Technical Guide

XJ and XK Series 1999 Model Year Update

Published by Service Communications, Jaguar Cars Limited
Publication Part No JJM 18 15 18/90, July 1998

Pistons

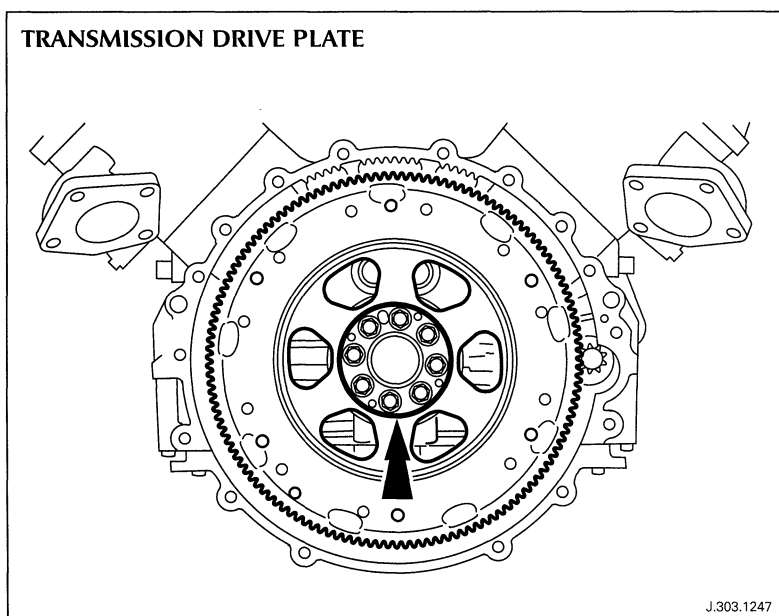
Modified pistons are fitted to the AJ27 4.0L N/A engine to allow for the increased timing advance of the new VVT system. The piston crown has cut outs to provide extra clearance for the inlet valves which, at full advance, open approximately 8° earlier BTDC compared to the AJ26 engine. Four cut outs are used to enable a common piston to be fitted in both engine banks.

Oil Cooling

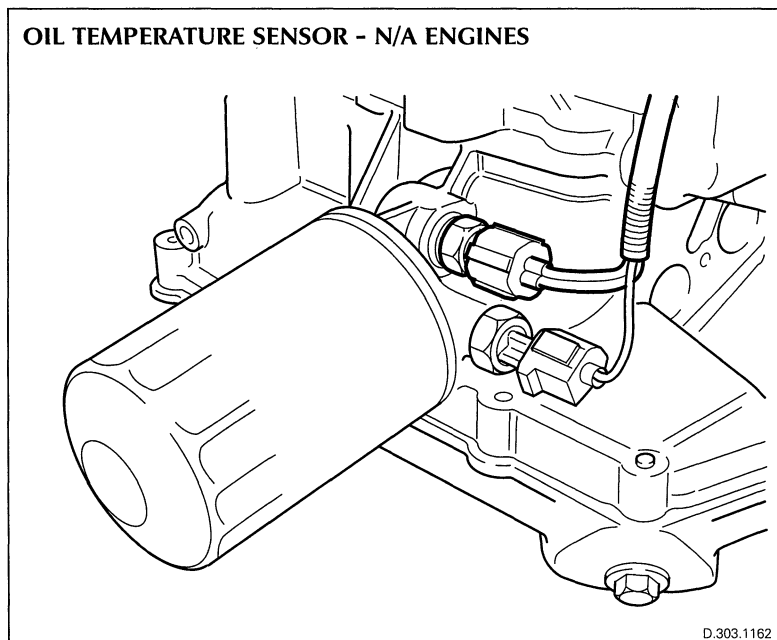
The external oil cooler is no longer fitted to N/A engines but is retained on the SC models. The oil diverter valve is therefore not required on N/A models.

INDUCTION MANIFOLD AND ELBOW

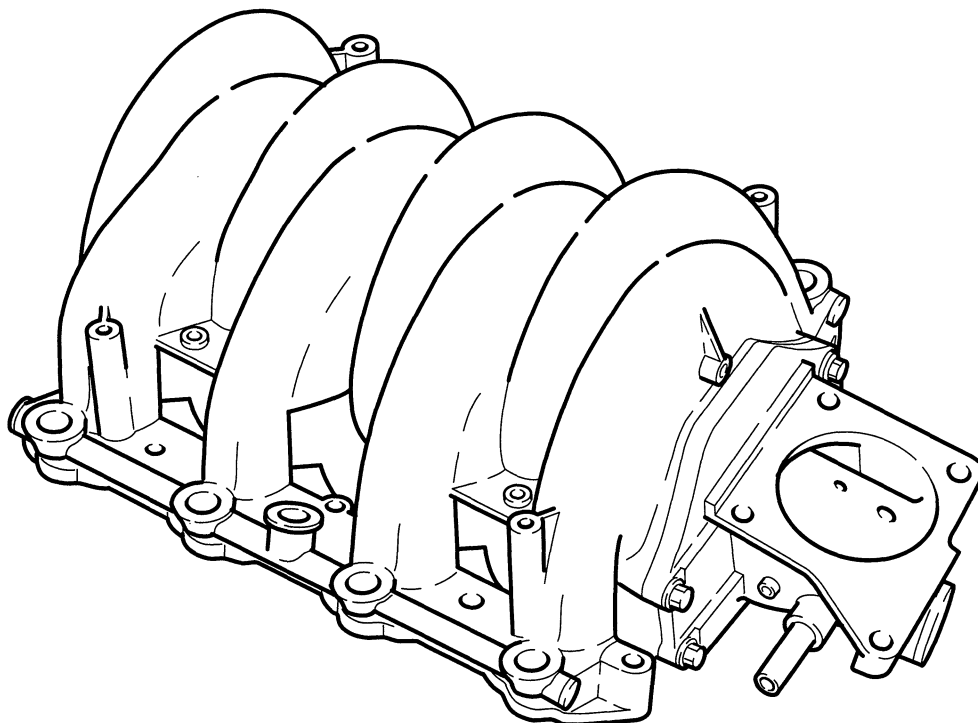
The induction manifold is modified to suit the new air assisted injectors and air feed system. Integral tubular air rails are located on each side of the manifold and fed at the centre point from detachable hoses. The fuel injectors are seated directly into the air rails and fuel is supplied to the top of the injector (top fed) from separate fuel feed rails bolted to the manifold. See 'Air Assisted Fuel Injection' (page 27).

The induction elbow has re-positioned fixing holes to accept the new throttle body.

ELECTRONIC THROTTLE

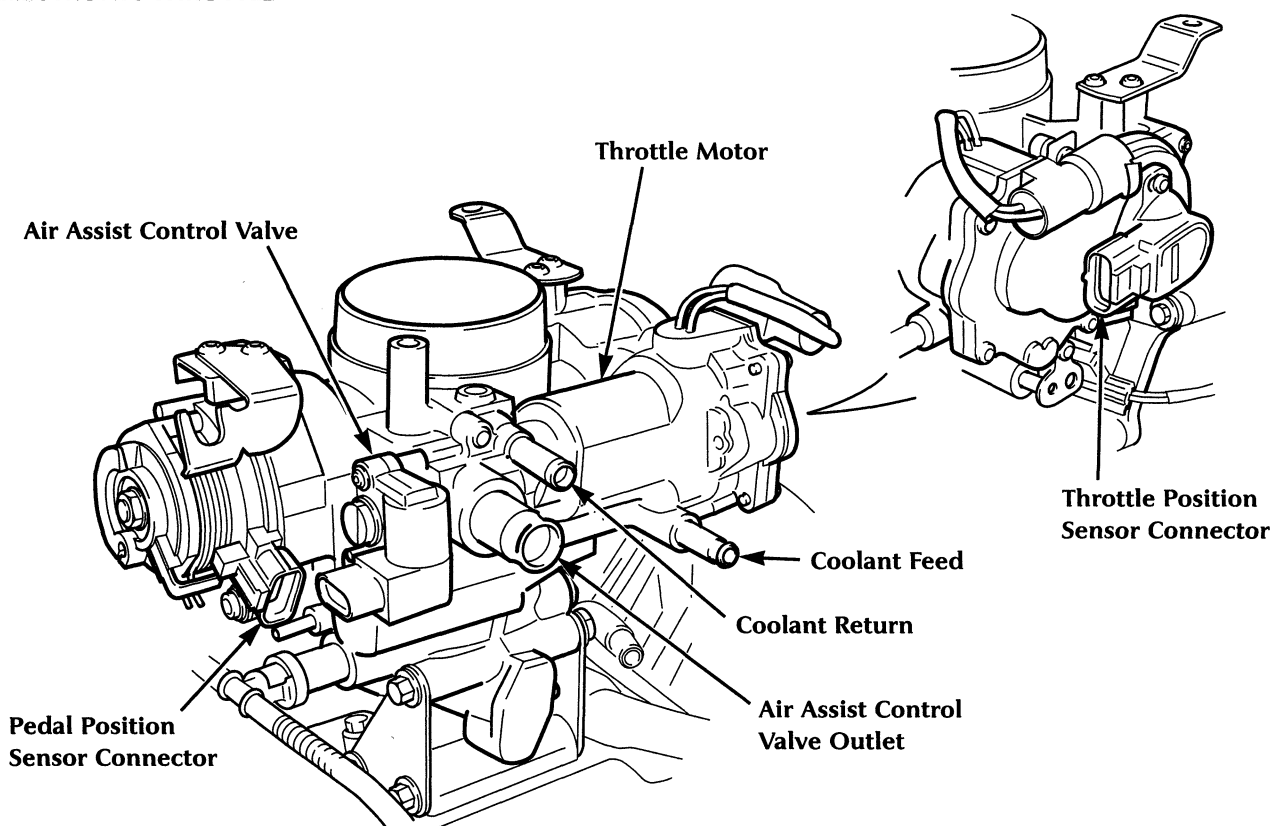
A new throttle body is fitted to the AJ27 4.0L N/A engine. The SC engines retain the existing electronic throttle with mechanical guard.

The throttle body contains two moving assemblies: the accelerator input assembly which provides the driver demand to the EMS control loop; and the motorized throttle valve driven and controlled by the EMS in accordance with driver demand and other EMS factors. In normal operation, there is no mechanical coupling between the two assemblies.

Linear Oxygen Sensor

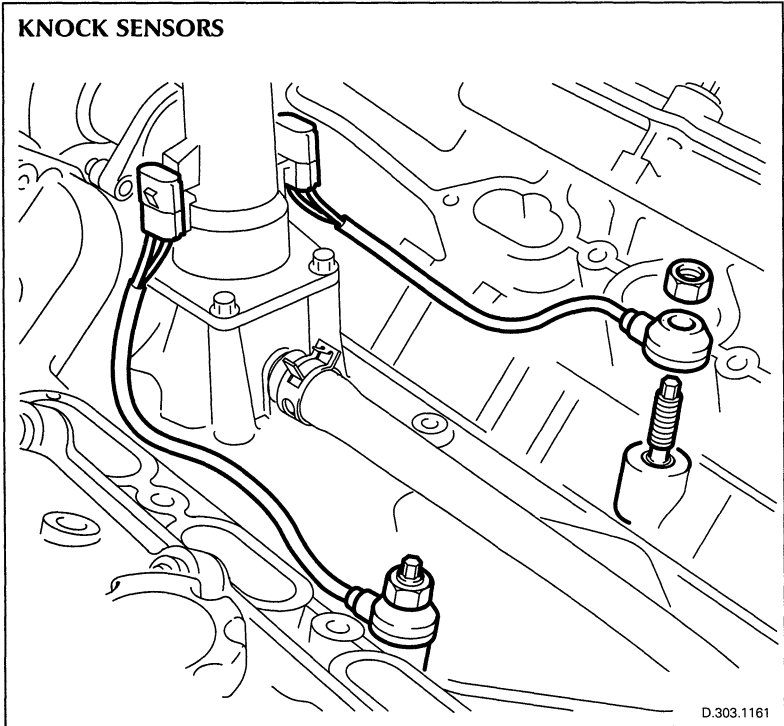
A new type of heated oxygen sensor is fitted in the upstream position for improved AFR control under varying engine conditions. The sensor has a constant voltage output with a linear current/AFR characteristic over an approximate AFR range from 12:1 to 18:1. This linear characteristic enables the sensor to provide very accurate feedback control. An HO₂ sensor of the type used previously in the upstream position is fitted in the downstream position and since it has a step response at stoichiometric AFR (sharp change in output voltage), provides a reference for the upstream linear sensor. The stoichiometric output of the downstream HO₂ sensor (450mV) is maintained more accurately than before by the use of the upstream linear sensor for feedback control.

Knock Sensors

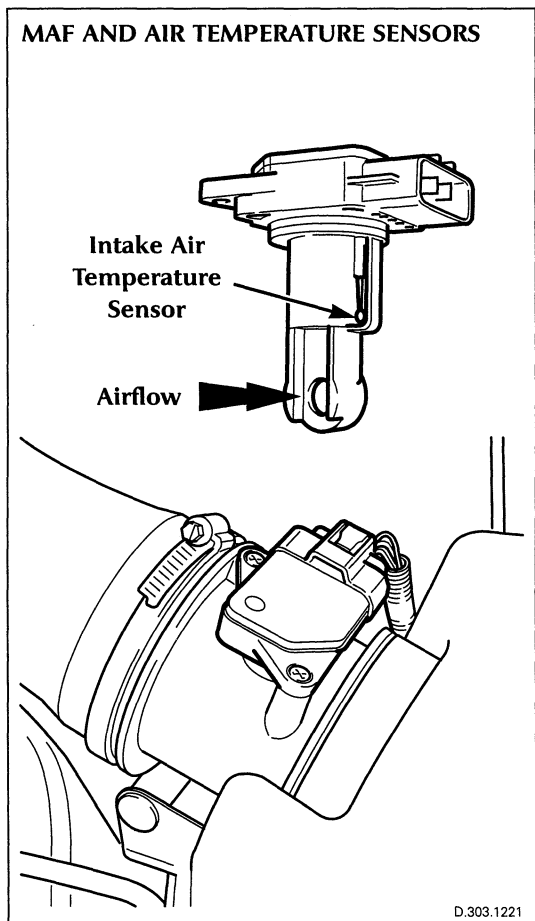
New type knock sensors are fitted to all N/A engines. The sensors are of an annular construction and are mounted via a stud and nut to the cylinder head. To improve cylinder identification, particularly at higher engine RPM, switched capacitive filters are incorporated in the new ECM. Knock sensing performance is further enhanced by the use of improved signal processing software.

COIL-ON-PLUG IGNITION UNIT

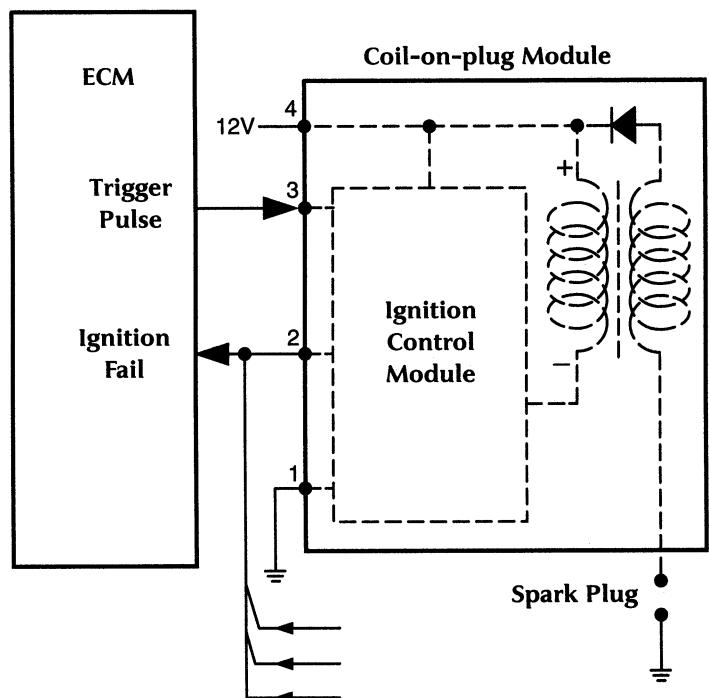
A new type coil-on-plug unit, which incorporates its own ignition control module, replaces the previous coil only type and the two separate drive modules. The new units are of integral, encapsulated construction with a fixed 4-pin connector.

Canisters

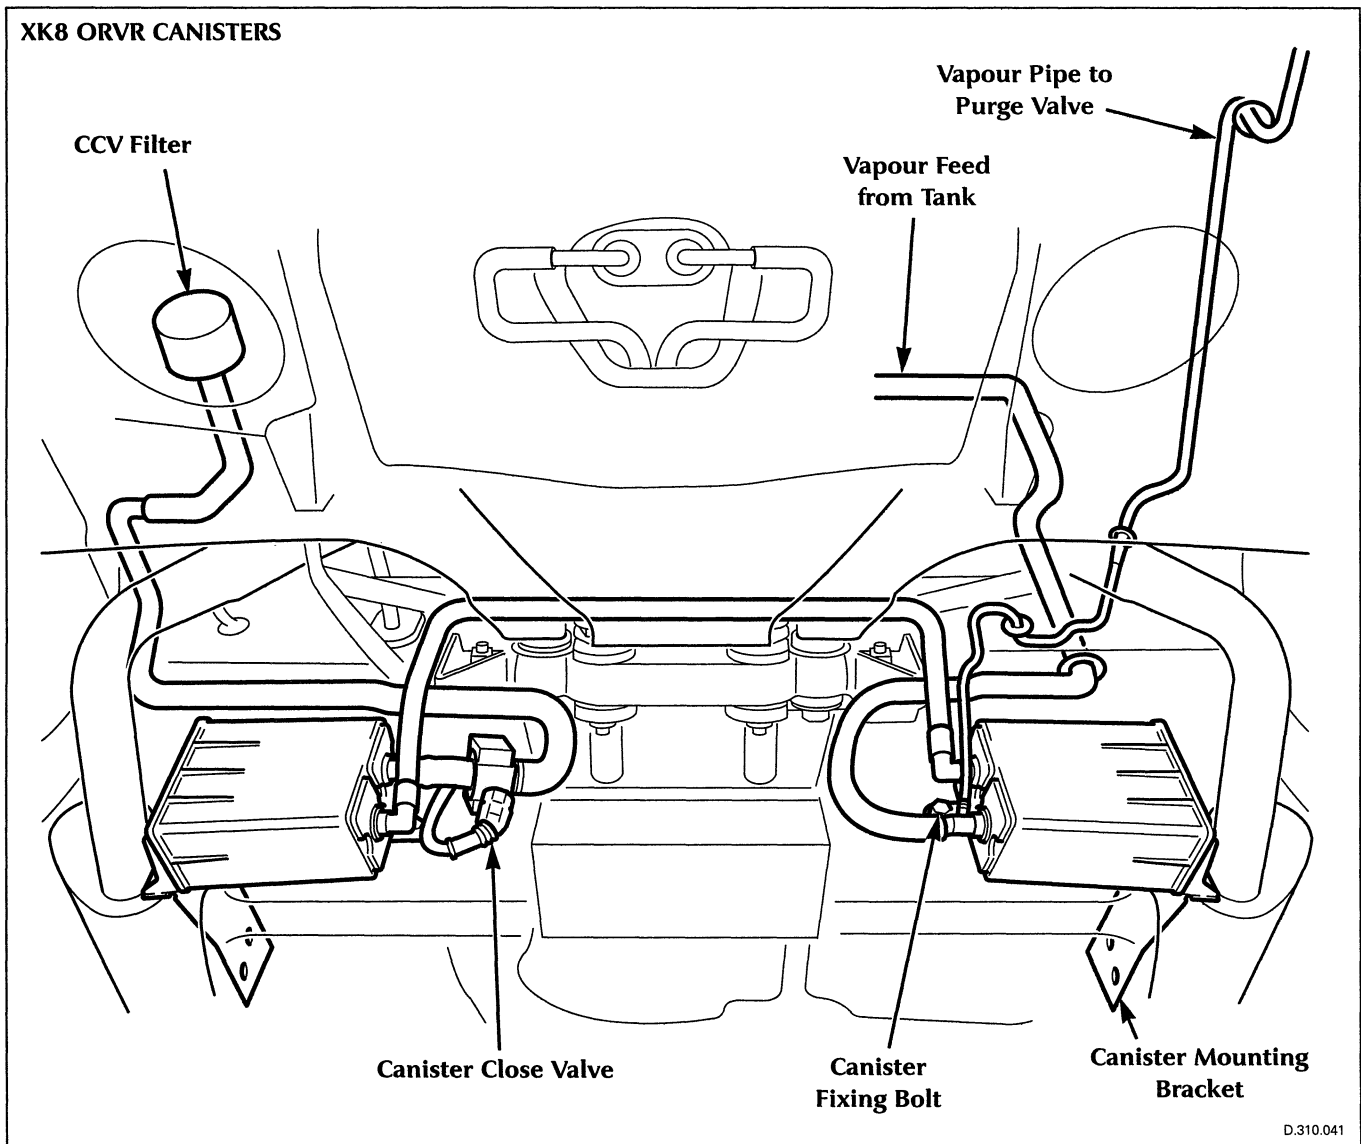
The evaporative emissions vapour purge system is now enhanced to include On-board Refueling Vapour Recovery (ORVR) for the 4.0L N/A engine and is similar to the system used on the sedan. Due to the large bore hoses required, the canisters and associated components are relocated to the rear of the vehicle behind the rear suspension/final drive assembly. The canister close valve and vapour hoses are fixed directly to the bodywork. The canisters are bolted directly and via brackets to the body. The atmospheric

vent pipe from the second canister is routed through a hole in the RH suspension housing with the CCV air filter fitted to the end of the pipe inside the housing.
